Work Order ID: 141705

Revision ID: URF15-560

Item Name: Replacement Skidtube with Wearpads, Fits LH or RH

KENT, WA			
DRAWING NO. D3887			
REV. D			
SHEET 1 OF 8			
TITLE A119 STD SKIDTUBE ASSY			
SCALE NTS			
COPYRIGHT © 2009 BY DART AEROSPACE USA, INC.			
THIS DOCUMENT IS PRIVATE AND CONFIDENTIAL AND IS SUPPLIED ON THE EXPRESS CONDITION THAT IT IS NOT TO BE USED FOR ANY PURPOSE OR COPIED OR COMMUNICATED TO ANY OTHER PERSON WITHOUT WRITTEN PERMISSION FROM DART AEROSPACE USA, INC.

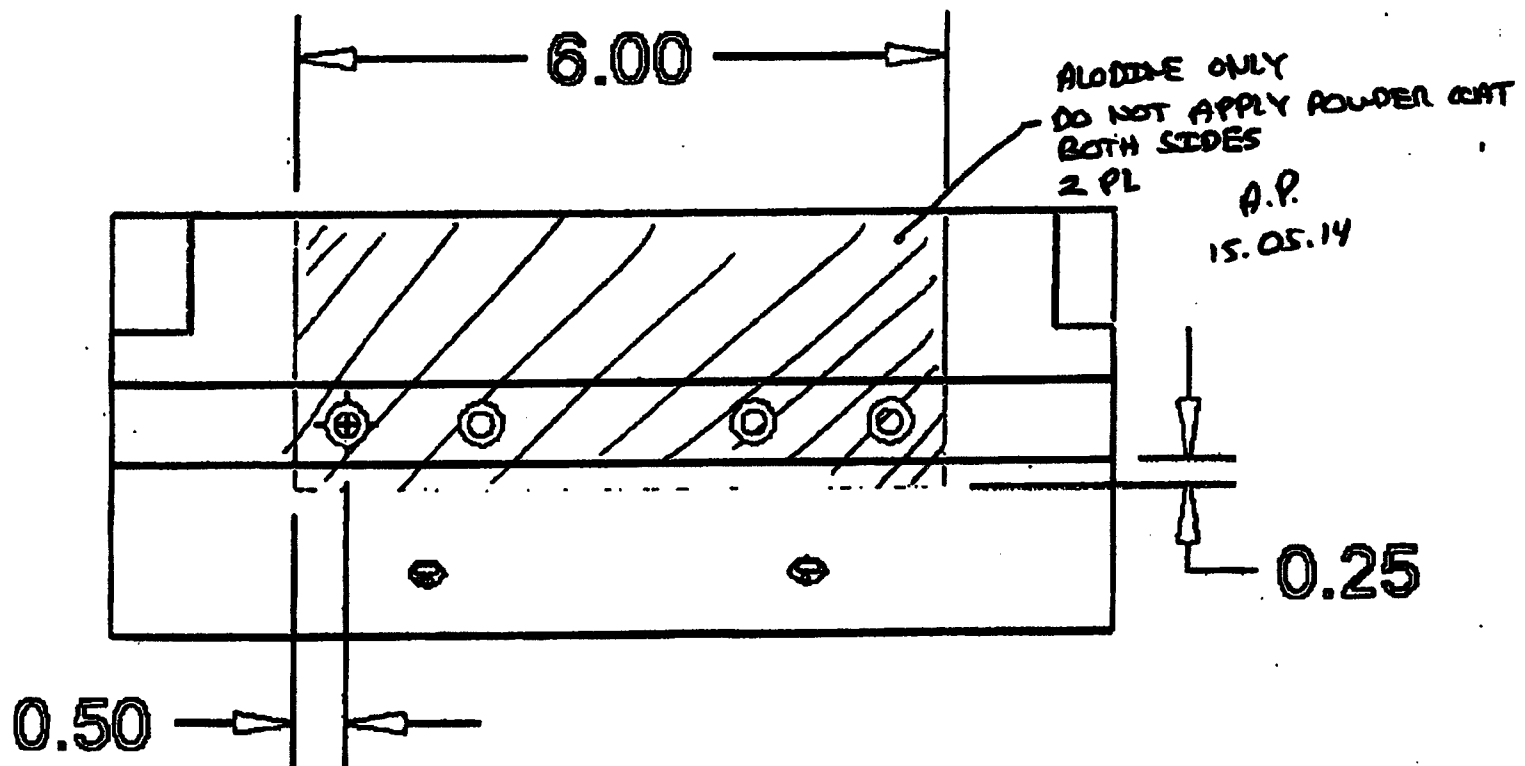
Description Work Order Deviation	Disposition	
Modify web prior to insertion for compatibility with DSI 5734	Drill / ovalize web per attached figure.	Completed By 16-2-16
	Dwg to be update	Lead hand / Supervisor Approval Verification PD 16-02-16
		QC / QA Coordinator Approval PD 16-02-16
